# Access Compliance Report

## Public Rights-of-Way

### (Curb Ramps)

Intersection ID: 13407	Main Street: PARK_HICKORY_DR	Cross Street: TRYSTING_RD	Location: NW
ADA ID: E47CE49CE5F3	Ramp Type: PerpDiag	Initial Pass/Fail: Fail	Overall Compliance: No
Codes/Mitigation Info/Possible Solution		Field Measurements/Component Compliance	
Severity Score: 8.75

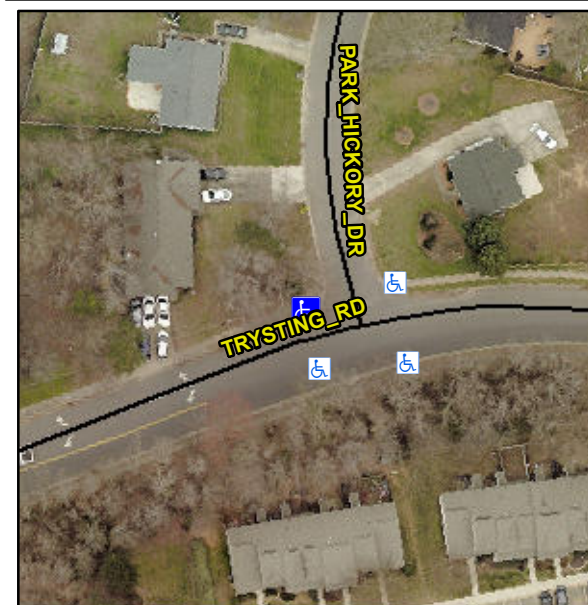
**Not Found, R304.5.1**

Compliance	Description	Data	Compliance	Description	Data
N/A	Ramp Length (in)	44.0	Yes	Ramp Slope (%)	5.7
No	Ramp Width (in)	47.5	Yes	Ramp XSlope (%)	0.5
N/A	Flare Type LT	N/A	N/A	Flare Type RT	N/A
N/A	Flare Slope LT (%)	N/A	N/A	Flare Slope RT (%)	N/A
N/A	Flare Traversable LT?	N/A	N/A	Flare Traversable RT?	N/A
N/A	Landing Length (in)	N/A	N/A	DWS Provided?	N/A
N/A	Landing Width (in)	N/A	N/A	DWS Contrast?	N/A
N/A	Landing Slope (%)	N/A	N/A	DWS Length (in)	N/A
N/A	Landing X Slope (%)	N/A	N/A	DWS Full Width?	N/A
N/A	Landing Curb? (Y/N)	N/A	N/A	DWS Offset (in)	N/A
N/A	Shared Landing?	N/A			
N/A	Gutter Ponding?	N/A	N/A	Gutter Slope (%)	N/A
N/A	Gutter Lip Ht (in)	N/A	N/A	Gutter X Slope (%)	N/A
N/A	Painted X Walk1?	No	N/A	Painted X Walk2?	No
	X Walk 1 Direction	To S		X Walk 2 Direction	To E
N/A	X Walk 1 Width (in)	N/A	N/A	X Walk 2 Width (in)	N/A
	X Walk 1 Slope (%)	5.4		X Walk 2 Slope (%)	3.9
	X Walk 1 X Slope (%)	1.7		X Walk 2 X Slope (%)	2.9

N/A	Ramp inside XWalk1?	N/A	N/A	Ramp inside XWalk2?	N/A
	Road Slope (%)	0.5	N/A	Clear Space?	N/A
	Road X Slope (%)	6.3	N/A	Clear Space to XWalk (in)	N/A
N/A	Any Obstructions?	N/A	N/A	Storm Grate/Utility Hazard?	N/A
	Obstruction Type			Storm Grate/Utility Type	
		N/A			N/A
			Yes	Surface Condition? (G/P)	Good

**Remove & Replace Curb Ramp With Two New Directional Ramps or Equivalent.**
